<del></del>		
Request	Applicaton No.	: 10/063,737	
For	Filing Date	: May 09, 2002	
Continued Examination	First Named Inventor	: Hsu	
(RCE)	Group Art Unit	: 2825	
Transmittal	Examiner	: Bowers, Brandon	
Address To:	A	: 8727-US-PA	
Commissioner for Patents	Attorney Docket No.		
220 20th Street South			
Customer Window, Mail Stop RCE			
Crystal Plaza Two, Lobby, Room 1B03			
Arlington, Virginia 22202			
Fax No.: 703-872-9319

In Re Appi	ıc	ation of:		)
BRANDON	J	Hsu	)	Examiner : BOWERS,
Serial No.		10/063,737	)	Art Unit : 2825
Filed	:	05/09/2002	)	Docket No.: 8727-US-PA
For	:	VOLTAGE REFERENCE CIRCU LAYOUT INSIDE MULTI- LAYERED SUBSTRATE	, Л <b>Т</b> ) )

# AMENDMENTS AND REQUEST FOR CONTINUED EXAMINATION (RCE) UNDER 37 CFR § 1.114

REPLACEMENT SHEET

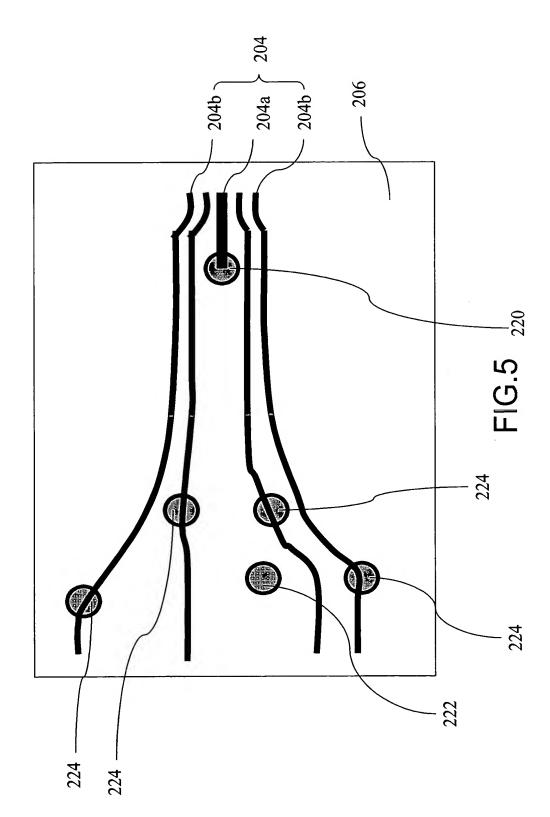
The Applicants have amended FIG.5 for including technique features cited in the

amended claim 16. The technique feature is described in paragraph 0034 in the

specification of the present application, and therefore no new matter is added.
